MUNRO'S PRESERVE JSP19-09

Public hearing at the request of Taft 11 Group LLC for Preliminary Site Plan With Open Space Preservation Option, Site Condominium, Wetland Permit, Woodland Permit and Stormwater Management Plan Approval. The Subject Property is located in Section 22, South of Eleven Mile Road and East of Taft Road and is Zoned R-4 (One Family Residential). The applicant is proposing to construct 17 single-family residential unit development (Site Condominium) utilizing the Open Space Preservation Option, with 2 additional single family parcels off of Danya's Way.

PLANNING REVIEW

Revised Preliminary Site Plan with Open Space Preservation Option

SITE PLAN

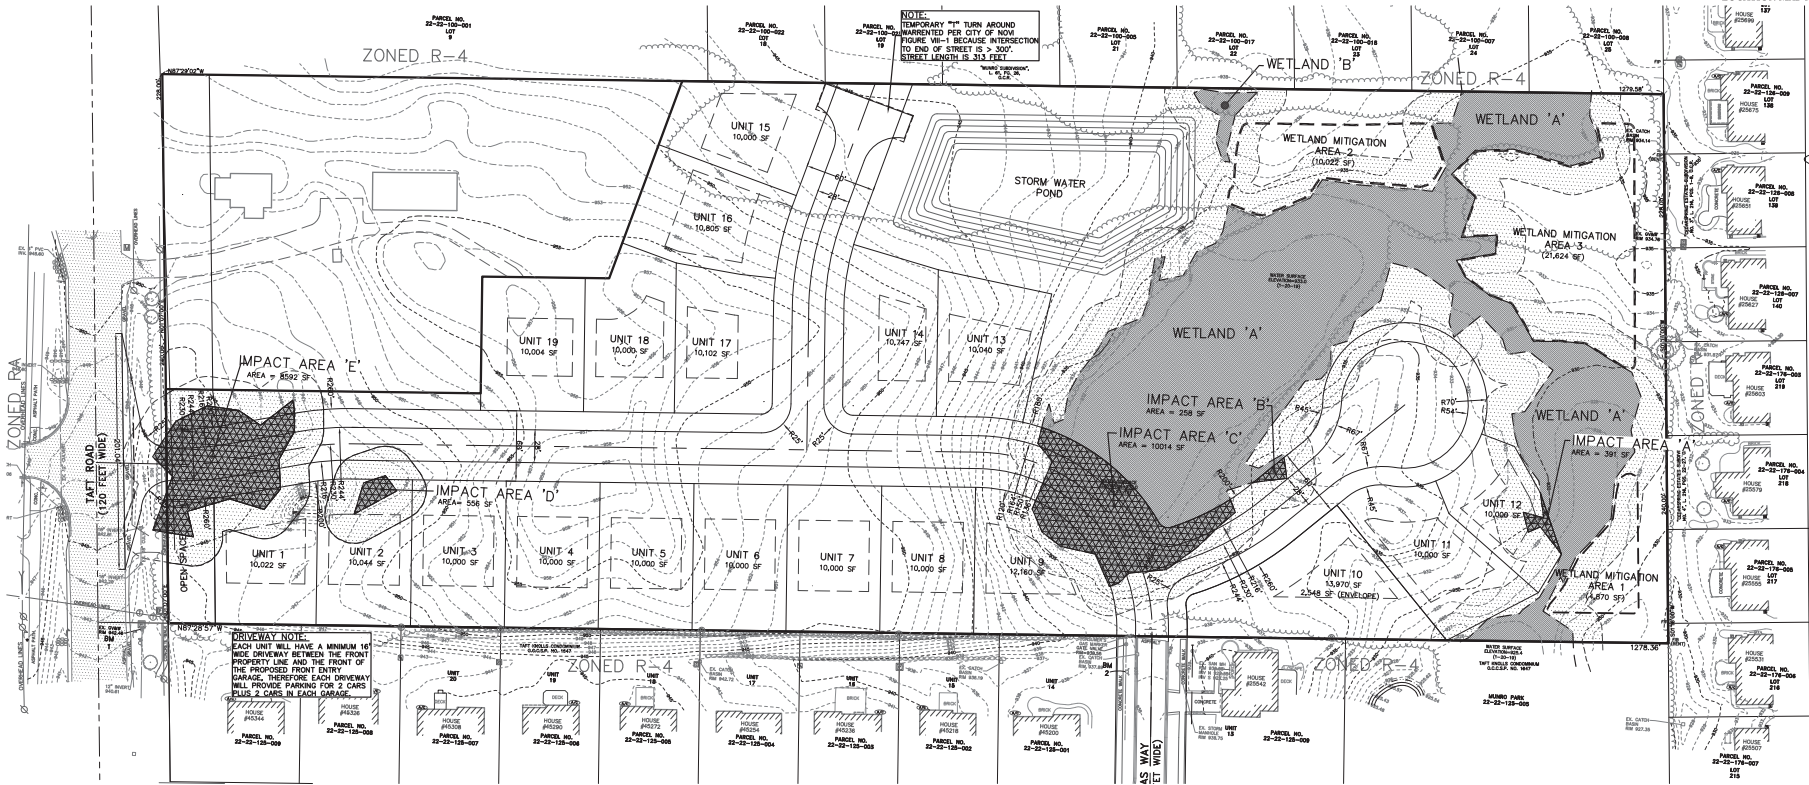
2. **Bona Fide or Parallel Plan:** A parallel plan is required, which identifies how the property could be developed under conventional developmental standards. A revised parallel plan was provided on 4/30/2019 (sheet 14) which indicates 19 lots can be developed under conventional development standards. The plan included additional details such as setbacks, frontage, conceptual storm water management and wetland fills. The applicant also removed a portion of the area that is not intended to be a party to the development. Staff reviewed the plan and has determined the proposed density may be allowable based on the maximum density proposed on the Parallel plan. Both the Open Space Preservation plan and the Parallel plan indicate 19 total lots. **The t-turnaround has been modified to accommodate the turning radius of a fire truck (30' inside, 50' outside) as required by fire department standards.**

It should be noted that the *Parallel Plan* (Sheet 14) includes a greater amount of proposed impact to wetland (0.45-acre of impact on the *Parallel Plan* compared to 0.21-acre of impact on the Plan). The wetland impacts associated with the *Parallel Plan* exceed the City's threshold for wetland mitigation of 0.25-acre of impact. The main difference with respect to proposed wetland impacts on the *Parallel Plan* is the proposed impacts to Wetland A for the development of an extended entrance drive as well as the development of Lots 9 and 12. The following table summarizes the proposed wetland impacts as listed on the *Parallel Plan* (Sheet 14):

- d. The applicant has indicated the T-turnaround for the extension of Danyas Way is to conform to dimensions requested by the Novi Fire Marshall.
 - e. The applicant has some provided dimensions for the "Parallel Plan" on sheet 14. The dimensions are generally consistent with the standards in the ordinances. More dimensions for the temporary turnaround should be included in future submittals if the parallel plan is selected. The current assumption is that the turnaround on the proposed spur road would be identical to the turnaround proposed to terminate Danyas Way based on the Fire Marshall's dimension stipulations.

2. *Parallel Plan:* The parallel plan has been revised to include the city's new turn around standards per our discussions with your office and the fire department. We understand that the city will be revisiting the City of Novi standard detail VIII-I. See the revised parallel plan on sheet 14.
